BELL SYSTEM PRACTICES
Teletypewriter and Manual
Telegraph Station and PHX
Installation and Manual

ADDENDUM P30.433
Issue A, 7-1-43
Long Lines Department
Dist. Class. 600AC

P 9.09

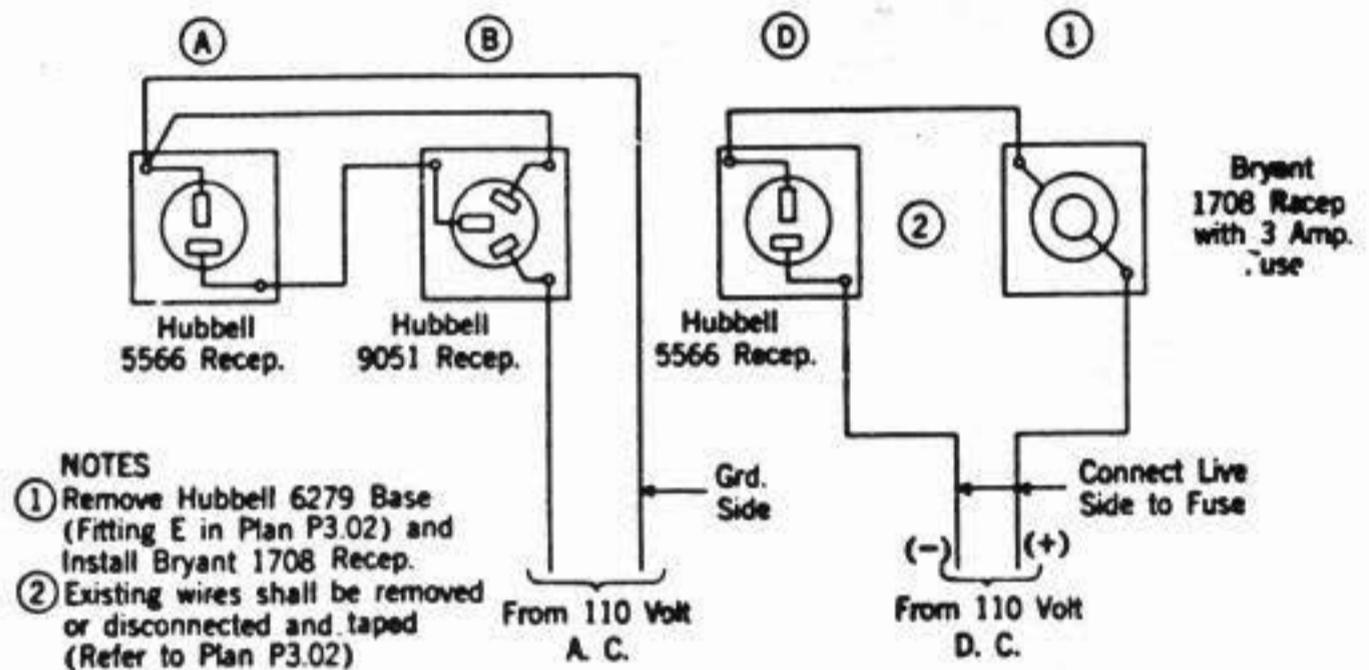
1.01 This addendum supplements Section P30.433 to add Connection Plan P9.09 which was formerly contained in Addendum P30.436, Issue A.
